Request	-	Amendment to Planned Unit Development, originally granted by Ord. 150-25, for a new library and storage building
Location	-	3027 Alexis Road
Applicant/Owner	-	Board of Trustees of the Toledo Lucas County Public Library 325 Michigan Street Toledo, OH 43604
Architect	-	Bostwick Design Partnership 2729 Prospect Avenue Cleveland, OH 44115
Engineer	-	DGL Consulting Engineers 3455 Briarfield Blvd, Suite E Maumee, OH 43537

PLANNED UNIT DEVELOPMENT  
TOLEDO CITY PLAN COMMISSION  
REF: PUD25-0002  
DATE: August 14, 2025  
TIME: 2:00 P.M.

PUD25-0002

# SITE PLAN

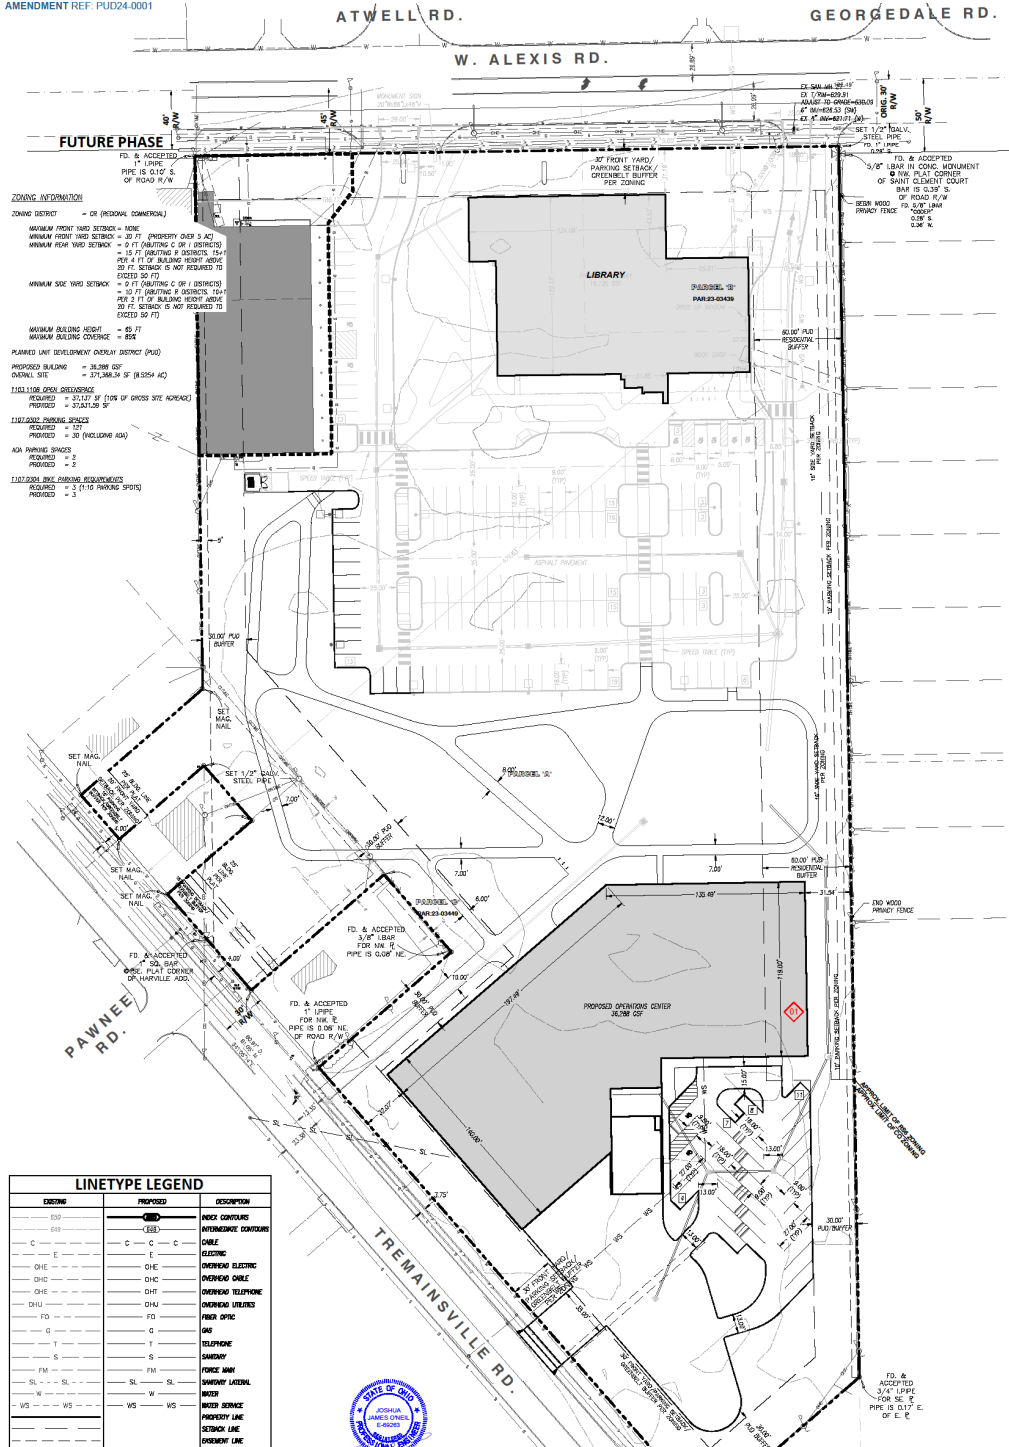
27. Per TMC§1103.1008(B) commercial PUD developments shall maintain a minimum open space depth of thirty feet (30') on all perimeter property lines and a minimum open space depth of sixty feet (60') when abutting a Residential District. This open space area must be void of buildings, structures, parking areas and other above ground improvements. The submitted site plans and elevations show that the operations center will be located within the required sixty-foot (60') open space along the east side of the site. **Not acceptable as depicted. The applicant shall obtain a waiver for the required open space depth where it does not comply or revise the site plan to comply with this requirement.**

- a. Per TMC§1108.0202, a minimum thirty-foot-wide frontage greenbelt along public rights-of-way is required that contains at least one (1) tree for every thirty-feet (30') of frontage. Nineteen (19) trees are required along Tremainsville Road and the tree planting plan depicts fifteen (15). Additionally, the frontage greenbelt shall include a solid evergreen hedge, which is not provided. **Not acceptable as depicted. An additional four (4) trees and a solid evergreen hedge shall be provided.**

- b. Per TMC§1108.0203, a Type A Buffer is required along a portion of the east property line and a Type B Buffer is required along the other portion of the east property line. These two (2) buffers require a total nineteen (19) canopy trees and seventy-one (71) shrubs along the eastern property line. The tree planting plan depicts fifteen (15) canopy trees and eight (8) understory trees for an equivalent of twenty (20) canopy trees. The shrub planting plan also depicts twenty-five (25) shrubs. **Not acceptable as depicted. An additional forty-six (46) shrubs shall be provided.**

- c. Per TMC§1108.0204, two (2) canopy trees and six (6) shrubs are required to be installed in interior landscape areas in a parking lot for each ten (10) parking spaces. A total of six (6) trees and eighteen (18) shrubs are required in the interior of the parking lot based on the proposed thirty (30) parking spaces. There is no landscaping provided for the parking lot. **Not acceptable as depicted. The required six (6) trees and eighteen (18) shrubs shall be provided.**

- d. Perimeter landscaping must be installed along the parking lot area adjacent to a street, place or driveway, or which is visible from an adjacent property. The frontage greenbelt counts toward perimeter landscaping requirements along Tremainsville Road. The proposed trees in the Type B Buffer along the east property line count towards the perimeter landscaping requirements; however, a solid evergreen hedge is required along the parking area to shield headlights from adjacent properties. **Not acceptable as submitted. A continuous shrub hedge shall be provided along the east side of the parking lot.**

- p. The location, lighting, and size of any signs.
31. Connecting walkways and pedestrian connections are required per TMC§1109.0204(A). At least one (1) main entrance shall face and open directly onto a five-foot (5') wide connecting walkway to the street sidewalk. **Not acceptable as depicted.** A five-foot (5') wide connecting walkway shall be provided from the main entrance at the rear of the building to the existing sidewalk on Tremainsville Road. The walkways shall be distinguished from driving surfaces where it crosses parking aisles or driveways.

# BUILDING ELEVATIONS

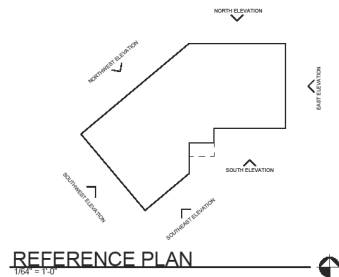
The submitted building elevations show the use of two (2) different architectural metal panels with differing profiles (varying panel reveal widths) that will be alternated on the building facades in a diagonal pattern. The color palette has not been finalized; however, the elevation details show four (4) different shades of grey. While the architectural metal panels are considered a predominant building material and therefore acceptable for use on the building facades, the building material and proposed colors are not consistent with the materials proposed for the library building to the north. In addition, the building materials as proposed do not assist with addressing the mass and scale of the building. The height of the building that is visible from Tremainsville Road is twenty-four feet (24') and includes one (1) long massing wall with minimal windows and no building articulation.

32. Building elevations must meet TMC§1109 – Design Standards. **Not acceptable as submitted. Revised elevations that meet these standards shall be submitted for review and approval by the Plan Director.**

While the use of the building will include storage and supportive services for the library system, it is located in the CR Regional Commercial zoning district and subject to commercial design standards to ensure compatibility with surrounding properties. In addition, the applicant has created a unique open space within the PUD north of the proposed building. Having a structure that reflects the human/pedestrian scale is not only important along Tremainsville Road, but also as it acts as boundary or enclosure along one side of the entrance into the open space and the open space itself. It is important to note that self-storage facilities are permitted uses in the CR zoning district. These types of facilities also provide storage. In two (2) recent plan review cases involving self-storage facilities located in a CR zoning district, building design was required to meet the standards in TMC§1109. The proposed elevations for the operation center do not meet the building design standards outlined in TMC§1109 - Design Standards. Revised building elevations that meet these standards shall be submitted for review and approval by the Plan Director. This is listed as a condition of approval.
